**STAFF REPORT**  
**COMMUNITY DEVELOPMENT DEPARTMENT**

HEARING DATE: 9/17/2020  
 TO: Planning & Zoning Commission  
 FROM: Joe Dodson, Associate Planner  
 208-884-5533  
 SUBJECT: H-2020-0060  
 Horse Meadows Subdivision  
 LOCATION: The site is located at 710 N. Black Cat, in the NW ¼ of the NW ¼ of Section 10, Township 3N., Range 1W.

Rezone of 5.33 acres of land from the R-4 zoning district to the R-8 zoning district and preliminary plat consisting of 26 single-family residential lots and 4 common lots on 4.71 acres, by Riley Planning Services.

B. Preliminary Plat (date: 9/1/2020)

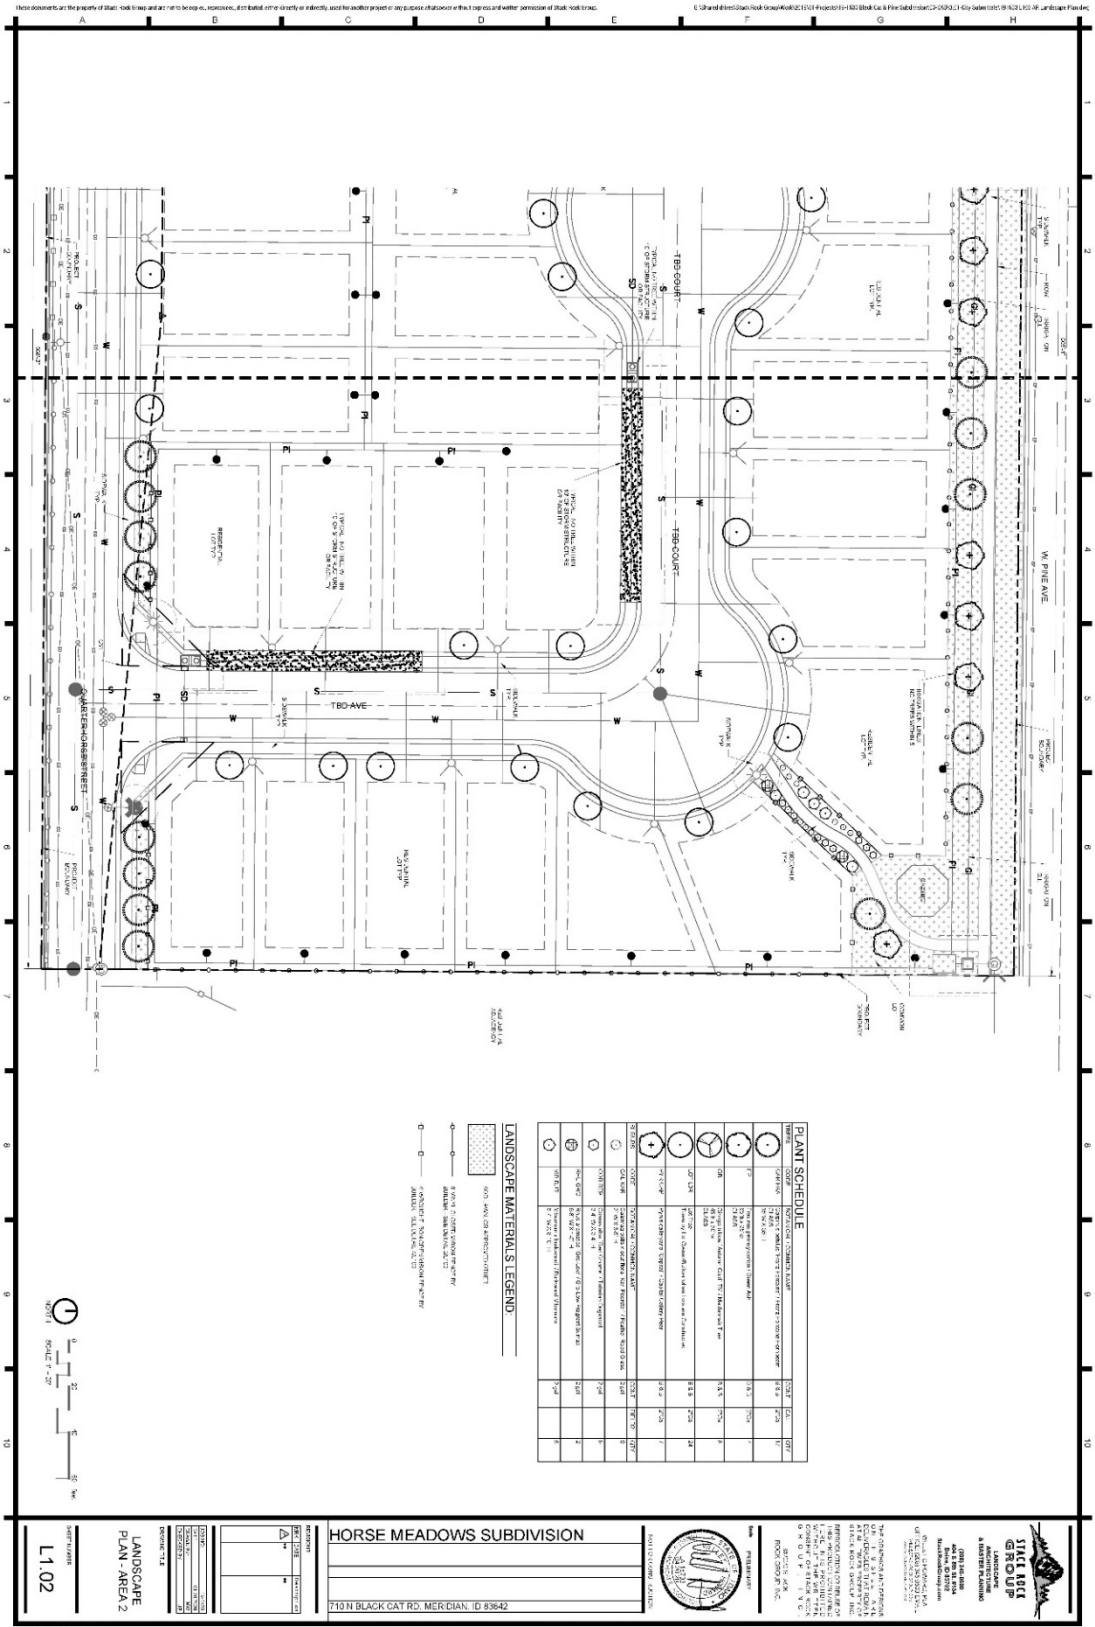
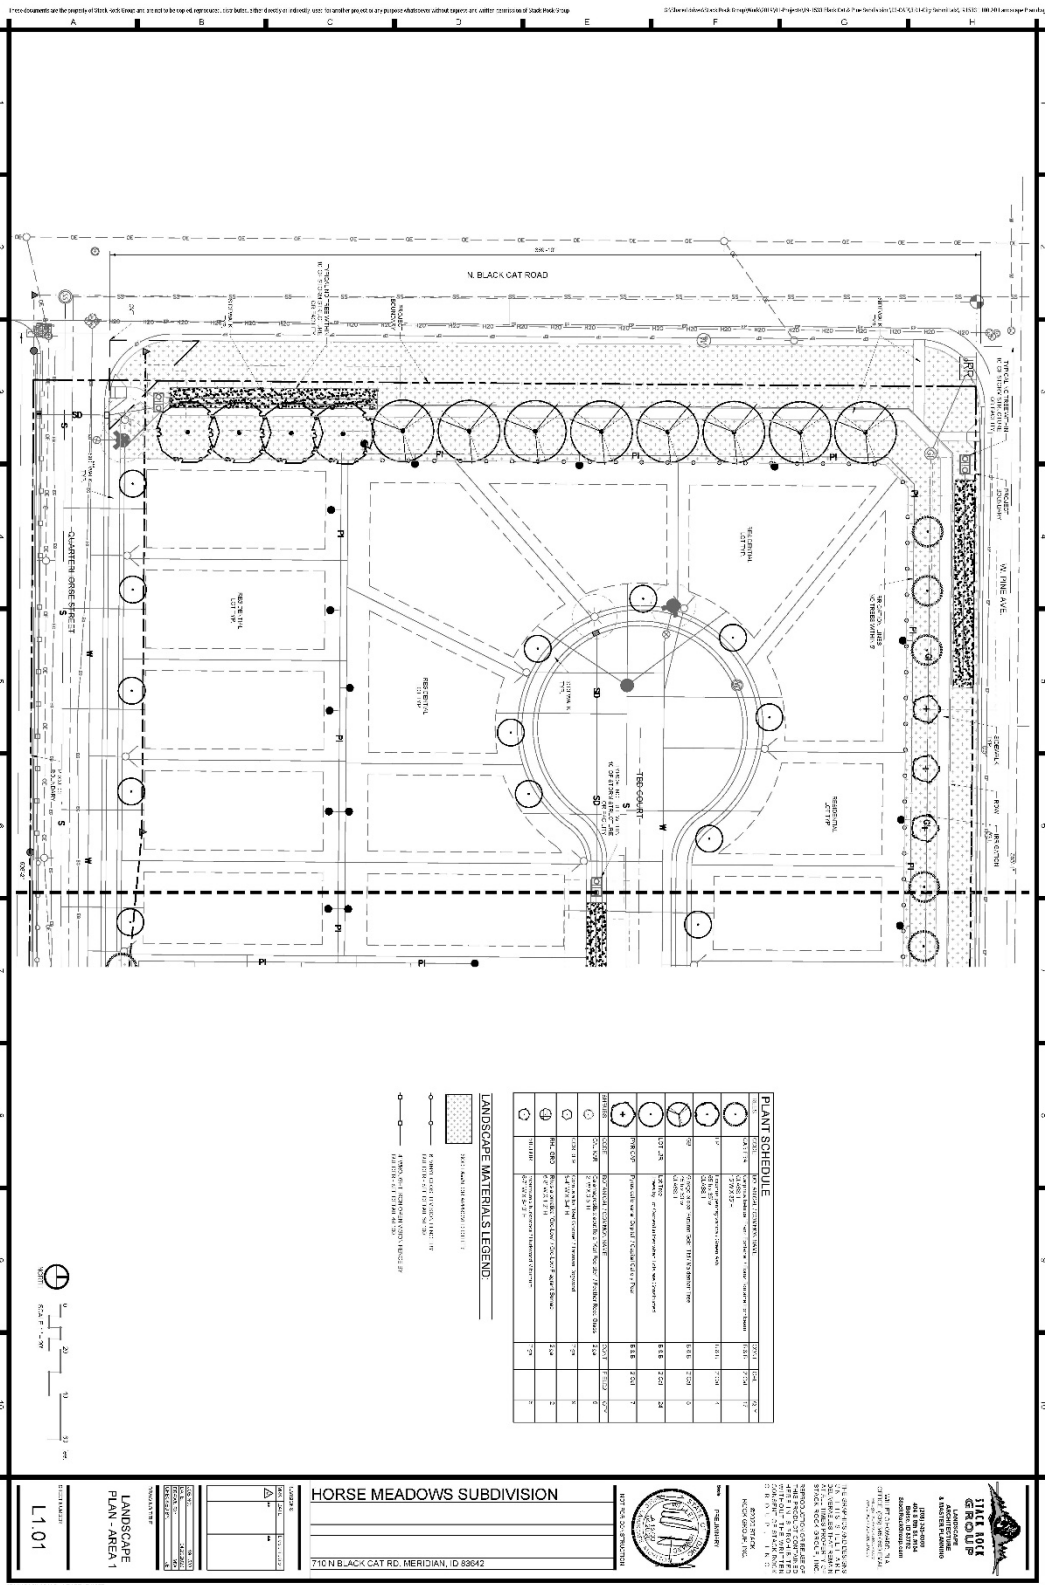
***The Applicant's revised plat shows front loaded single-family homes as a majority of the proposed use but it also shows four homes that are alley-loaded and two homes that are proposed with side-loaded garages. This is a change from any previous plat submitted to Staff and would allow different architectural styles of homes within the same development. Staff is appreciative of this proposal and is recommending a DA provision to ensure these homes are constructed as proposed and not as all front loaded.***

*The new layout proposes access off of Pine Avenue in line with N. Traquair Place on the north side of Pine. The internal streets provide two north-south stub streets to the existing private lane (Quarterhorse Lane) that will be extended in the future and a cul-de-sac that connects back to the westerly north-south street via an alleyway. This alleyway is where the Applicant is proposing the alley-loaded and side-loaded homes. Staff can support this revised layout more than previously submitted plats as it places the easement within a lot of its own, shown as Lot 9, Block 1. However, this lot is not specifically addressed on the plat or within the revised narrative. Therefore, the Applicant has not shown sufficient evidence how this layout and the existing easement could work in the future with future development to the east, specifically with the future*

***The street sections (33-feet wide) of the proposed local streets within the development, as shown on the submitted plat, accommodate parking on both sides of the street where no driveways exist. The cul-de-sac is proposed with a radius of 48 feet and cannot accommodate any parking along its perimeter.***

2. At least ten (10) days prior to the City Council hearing, the preliminary plat included in Section VII.B, dated 09/01/2020, shall be revised as follows:

- a. Add a note prohibiting direct lot access via N. Black Cat Road.
    - b. Revise the plat to show the detached sidewalks along N. Black Cat Road and W. Pine Avenue with at least 4 feet of separation between it and the ultimate ACHD right-of-way.

- c. **Add a plat note stating that Lot 9, Block 1 is a non-buildable lot and is to be owned and maintained by the HOA until such time that it redevelops.**

C. Landscape Plan (date: 4/20/2020) (NOT APPROVED)

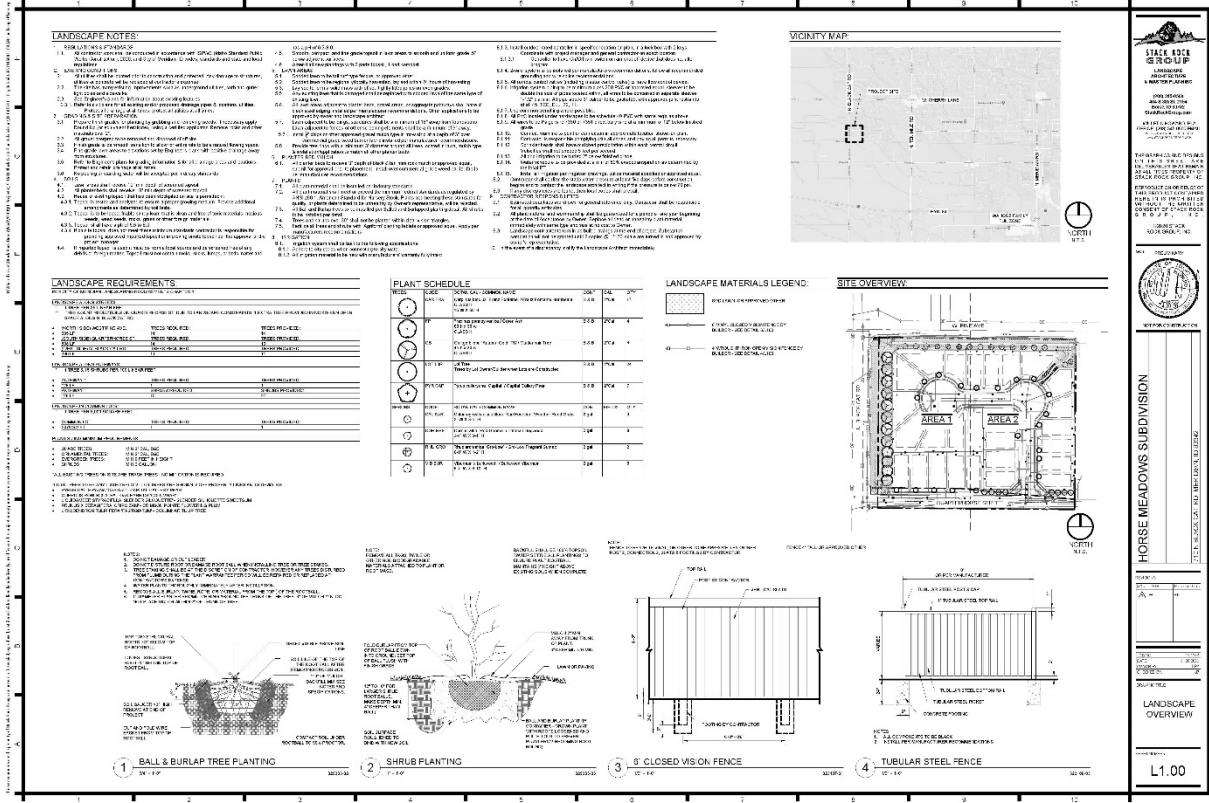
*The submitted plat depicts a 25-foot wide landscape buffer along Black Cat and a 20-foot wide buffer along Pine, both within common lots. The correct number of trees appeared to be shown on the original landscape plans as well (see Section VII.C). To ensure these buffers are installed and vegetated appropriately, the improvements required outside of the ultimate ROW should be constructed prior to receiving building permit approvals. Code also dictates that street landscape buffers are to be vegetated with shrubs, lawn, or other vegetative ground cover **in addition to trees**; the submitted landscape plans do not appear to show this vegetation. Staff is recommending a condition of approval to revise the landscape plans to correct this as well as revise the landscape plan to match the revised plat layout and be submitted to Staff no later than ten (10) days prior to the City Council hearing.*

All fencing is required to comply with the standards listed in UDC 11-3A-7. Fencing is shown on the landscape plan and appears to meet UDC requirements in regards to height, type, and location. *The Applicant should ensure fencing still meets the required UDC standards once providing a revised landscape plan that matches the revised plat.*

3. At least ten (10) days prior to the City Council hearing, the landscape plan included in Section VII.C, dated 04/20/2020 shall be revised as follows:

- a. Revise the landscape plan to show the required shrubs and other vegetative ground cover within the street landscape buffers along N. Black Cat Road and W. Pine Avenue.

- b. Revise the landscape plan to show the layout of the revised preliminary plat; make any adjustments to the calculations table if needed.
    - c. Revise the landscape plans to show the detached sidewalks along N. Black Cat Road and W. Pine Avenue with at least 4 feet of separation between it and the ultimate ACHD right-of-way.

D. Conceptual Building Elevations

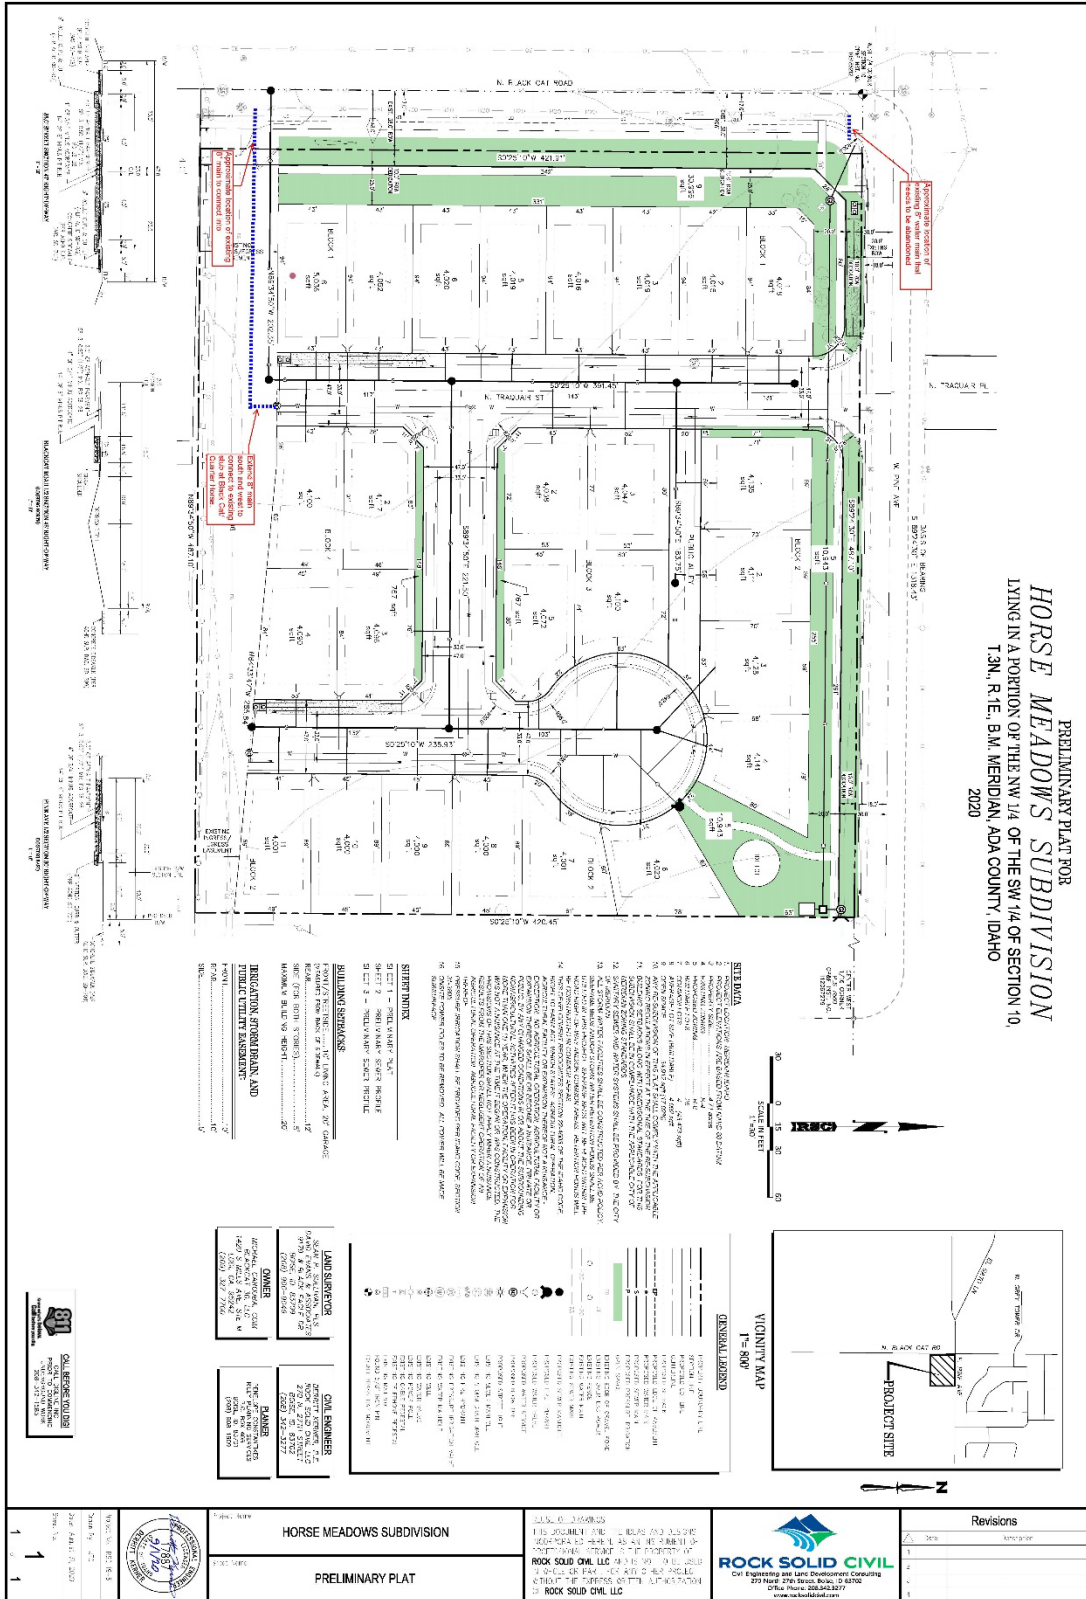
*The submitted elevations show a combination of single and two-story single-family homes. The elevations also show different architectural elements, finish materials, and overall design options including some RV size garage spaces. However, the Applicant has not provided conceptual elevations of the alley-loaded or side-loaded unit types. Prior to the City Council hearing, the Applicant should provide these conceptual elevations. Design review is not required for single-family detached structures but Staff finds the submitted elevations meet the requirements in the Architectural Standards Manual. Because a number of the homes abut streets that are heavily traveled, Staff is recommending a condition of approval that requires those homes abutting both Black Cat and Pine are constructed with modulation and variations in materials to mitigate any potential of a monotonous wall plane along these streets.*

4. Prior to the Commission hearing, the Applicant shall provide the following to Planning Staff: 1) building elevations depicting those homes that are alley-loaded and side-loaded, and; 2) exhibits showing setback compliance with the proposed building lot sizes and different style homes.

10. The façade of structures that face N. Black Cat Rd. and W. Pine Ave. shall incorporate articulation through changes in materials, color, modulation, and architectural elements (horizontal and vertical) to break up monotonous wall planes and roof lines in accord with UDC 11-3A-19 and the Meridian Design Manual.
